dcmc_sep_exc_8.sqproj

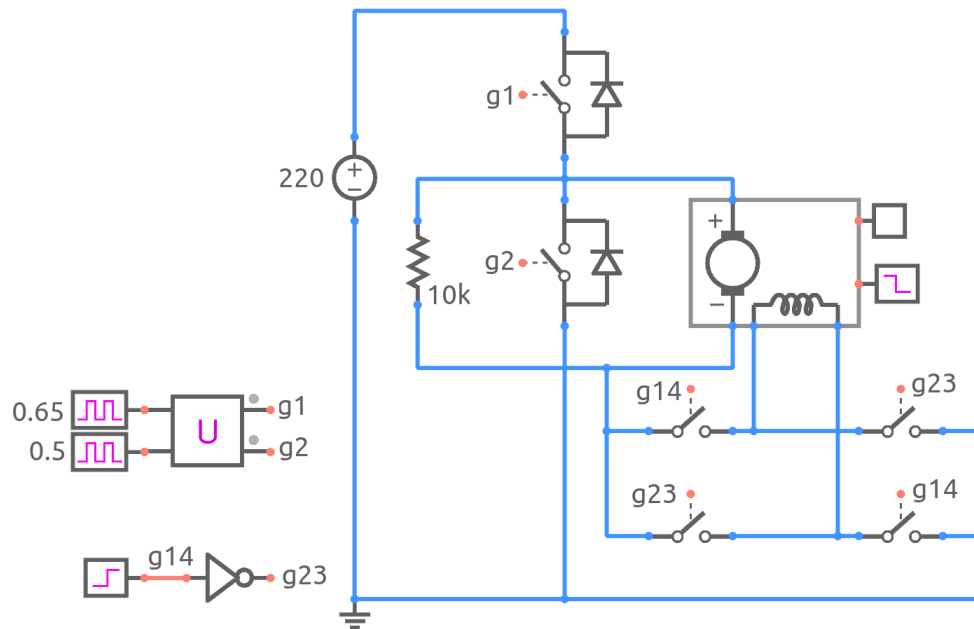
Note: $b_{\text{damp}}=0 \rightarrow$ unstable after torque reversal.
Make it non-zero.
